Preliminary Field Check For Drip Systems

ENGINEER'S OFFICE

RE: *1316 Lonesome
Canyon Lake Acres 2
Lot 470 & 471
Known as "Drain" between Lots 469 and 472*

ON-SITE SEWAGE FACILITY APPLICATION

OWNER: HIGHLAND VISTA DEVELOPMENT COMPANY			DRAWN BY: EJS III	
STREET ADDRESS: 1316 LONESOME				
LEGAL DESC: CANYON LAKE ACRES	UNIT/SECTION/PHASE: 2	BLOCK:	LOT: 470 & 471	
PREPARED BY: GREG W. JOHNSON, P.E. F#002585	SCALE: 1"=20'	DATE: 1/10/2025	REVISED:

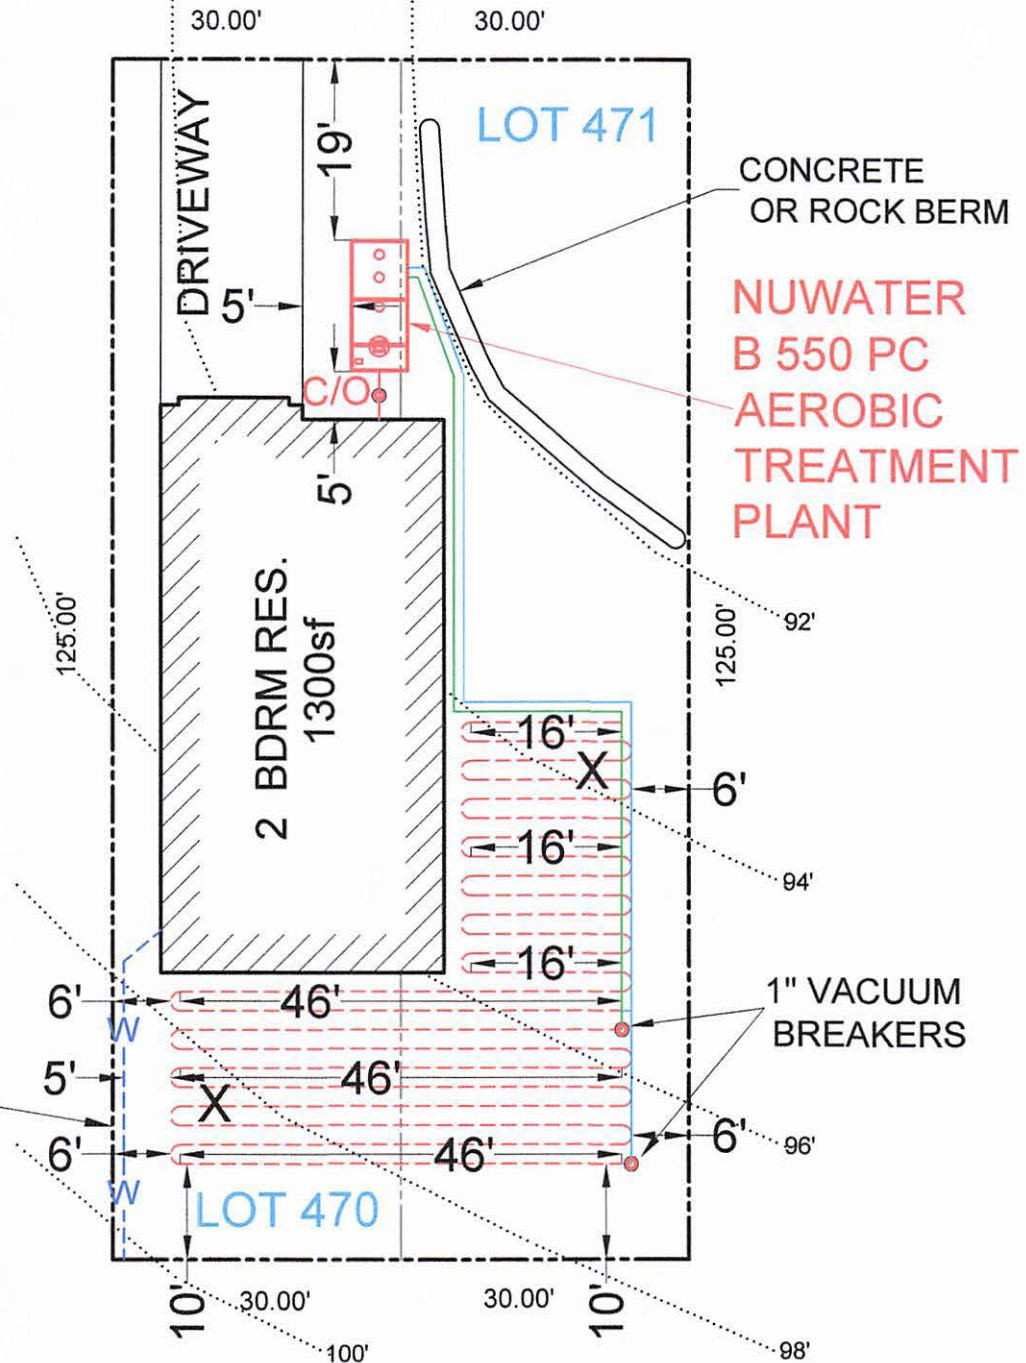
1. Indicate on all documents where it states Lot 470 and 471: *Known as "Drain" between Lots 469 and 472*
2. Note: there are no middle lot lines shown on the drain property.
3. Revise accordingly and resubmit.
